Access Compliance Report

Public Rights-of-Way

(Curb Ramps)

Intersection ID: 28345		Main Street: BACARDI_CT		Cross Street: HIRSCH_DR		Location: NE			
ADA ID: 3AE791B50603		Ramp Type: Perp		Initial Pass/Fail: Fail		Overall Compliance: No		Severity Score: 10	
Codes/Mitigation Info/Possible Solution				Field Measurements/Component Compliance

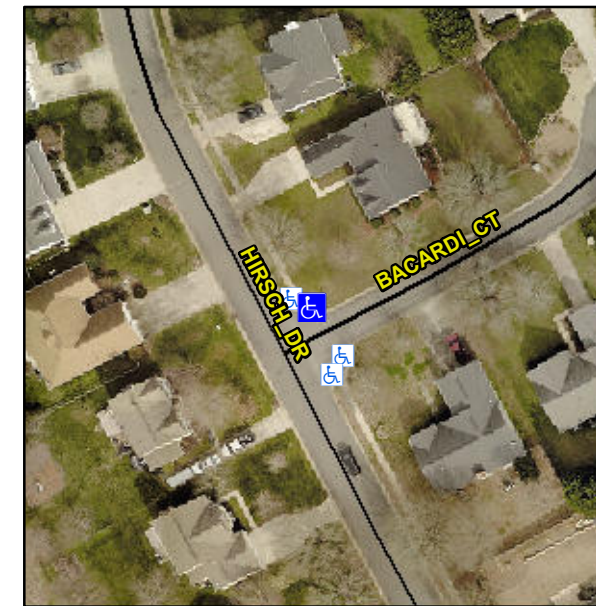
Not Found, R304.5.1, R304.5.3

Compliance	Description	Data	Compliance	Description	Data
N/A	Ramp Length (in)	97.0	Yes	Ramp Slope (%)	5.6
No	Ramp Width (in)	36.0	No	Ramp XSlope (%)	3.0
N/A	Flare Type LT	N/A	N/A	Flare Type RT	N/A
N/A	Flare Slope LT (%)	N/A	N/A	Flare Slope RT (%)	N/A
N/A	Flare Traversable LT?	N/A	N/A	Flare Traversable RT?	N/A
N/A	Landing Length (in)	N/A	N/A	DWS Provided?	N/A
N/A	Landing Width (in)	N/A	N/A	DWS Contrast?	N/A
N/A	Landing Slope (%)	N/A	N/A	DWS Length (in)	N/A
N/A	Landing X Slope (%)	N/A	N/A	DWS Full Width?	N/A
N/A	Landing Curb? (Y/N)	N/A	N/A	DWS Offset (in)	N/A
N/A	Shared Landing?	N/A			
N/A	Gutter Ponding?	N/A	N/A	Gutter Slope (%)	N/A
N/A	Gutter Lip Ht (in)	N/A	N/A	Gutter X Slope (%)	N/A
N/A	Painted X Walk1?	No	N/A	Painted X Walk2?	N/A
	X Walk 1 Direction	To SE		X Walk 2 Direction	N/A
N/A	X Walk 1 Width (in)	N/A	N/A	X Walk 2 Width (in)	N/A
	X Walk 1 Slope (%)	0.5		X Walk 2 Slope (%)	N/A
	X Walk 1 X Slope (%)	2.0		X Walk 2 X Slope (%)	N/A

Remove & Replace Entire Ramp.
